SUBJECT: KINGSTON STEAM PLANT - ANNUAL POWER ENGINEERING AND CONSTRUCTION AND FOSSIL AND HYDRO POWER JOINT INSPECTION OF THE ASH DISPOSAL AREA

TITLE KINGSTON STEAM PLANT - ALL UNITS - ANNUAL JOINT INSPECTION BY THE DIVISION OF POWER ENGINEERING AND CONSTRUCTION AND THE DIVISION OF FOSSIL AND HYDRO POWER			REPORT NO. FEP-ASH-88-04
			PLANT/UNIT KIF-ALL UNITS
			SAR SECTIONS
VENDOR	CONTRACT NO.	KEY NOUNS	
		UNID SYSTEM(S)	
	REV	(FOR RIMS USE)	RIMS ACCESSION NUMBER
	R0		B65 '88 0511 001
APPLICABLE DESIGN DOCUMENTS	R1		
	R2		
REFERENCES	R3		
	R4

KINGSTON STEAM PLANT

ASH DISPOSAL AREAS

① REDWATER COLLECTION DITCH.

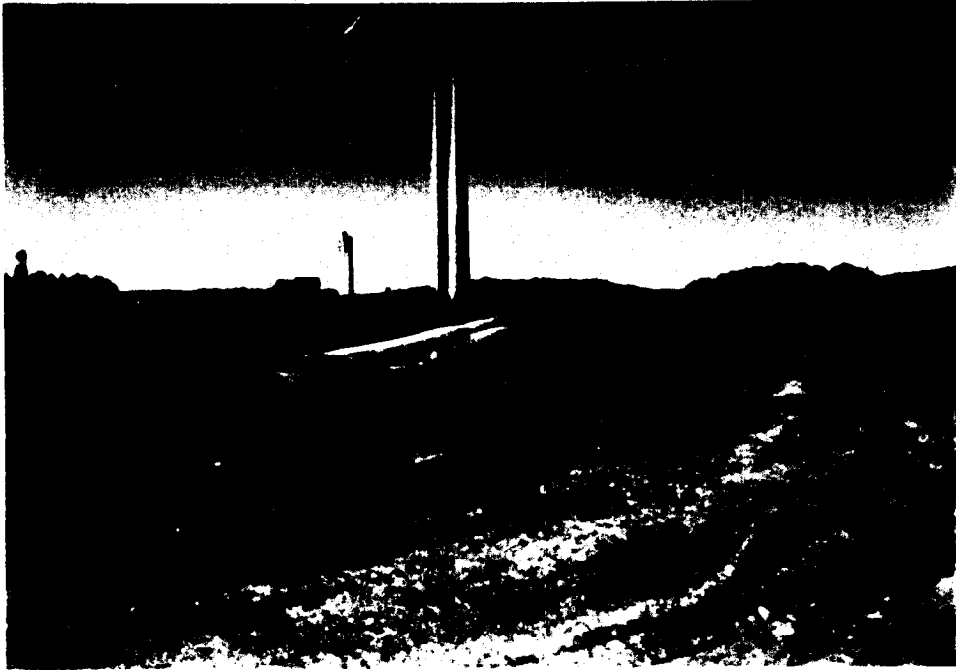
- 2.2 Seepage of redwater still persists along the exterior slope of the southeast dike near its southern end. The majority of the redwater drainage in this area of the disposal area is collected in an interceptor ditch and routed to an engineered wetland for treatment before discharging into the intake channel. At the present time, the discharge to the intake channel has been cut off and is being pumped to the ash pond. The wetland consists of several shallow ponds with cattails and is located as shown on the attached drawing 10W420.

4 FLOATING ASH AND SPILLWAY SKIMMERS.

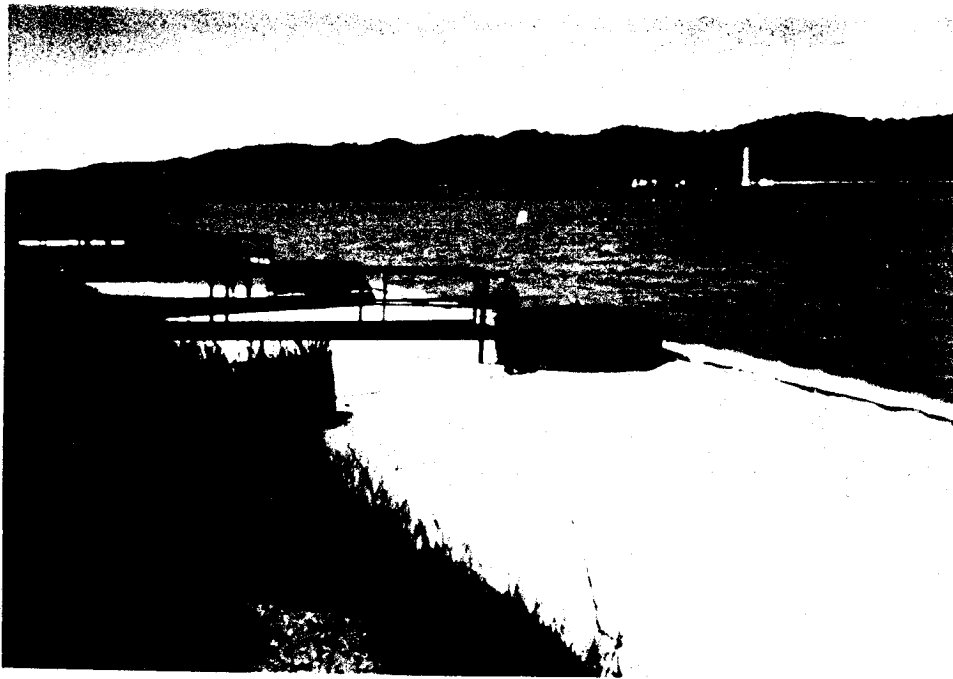
- 4.2 There was a considerable amount of floating ash trapped behind the floating skimmer around the standard spillways and skimmers. Due to this build up of ash, there was a noticeable loss of ash into the spillways (see recommendation No. 6.2).

- 4.4 The outlet area for these spillways has a good rip rap cover, and the concrete head wall appears to be in good condition. There was noticeable loss of ash into the plant intake channel. The plant has a floating skimmer in front of the intake structure to skim off the floating ash lost to the intake channel. (See recommendation No. 6.2).

- 6.1 All small trees and brush should be removed from the dike's slopes as needed. It is recommended that this undesirable vegetation be removed by chain or cable as to remove the root system from the earth.
- 6.2 The floating ash within the stilling pool needs to be removed to prevent loss through the spillways.
- 6.3 All limbs and algae need to be removed from the spillway skimmers.

5 SPILLWAY

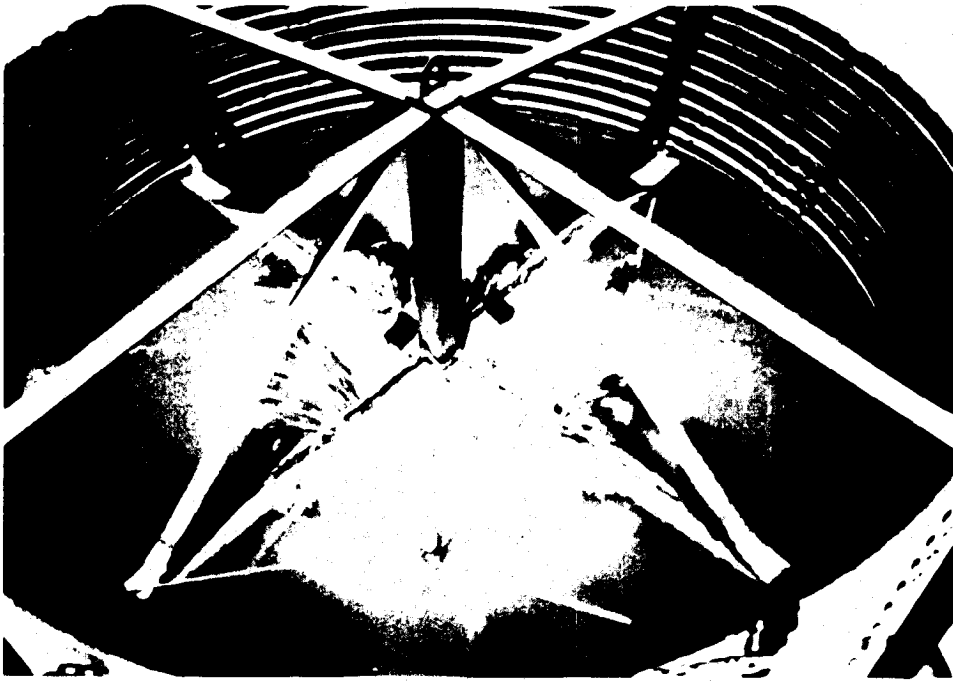
- 4.3 Five of the six standard spillways and skimmers in the stilling pool area appear to be in good condition and functioning properly. The spillway on the west end has been raised one section higher than the other spillways and is not discharging. Several small limbs and a build up of algae was noticed around the spillways and skimmers which could cause inaccurate discharge readings (see recommendation No. 6.3).
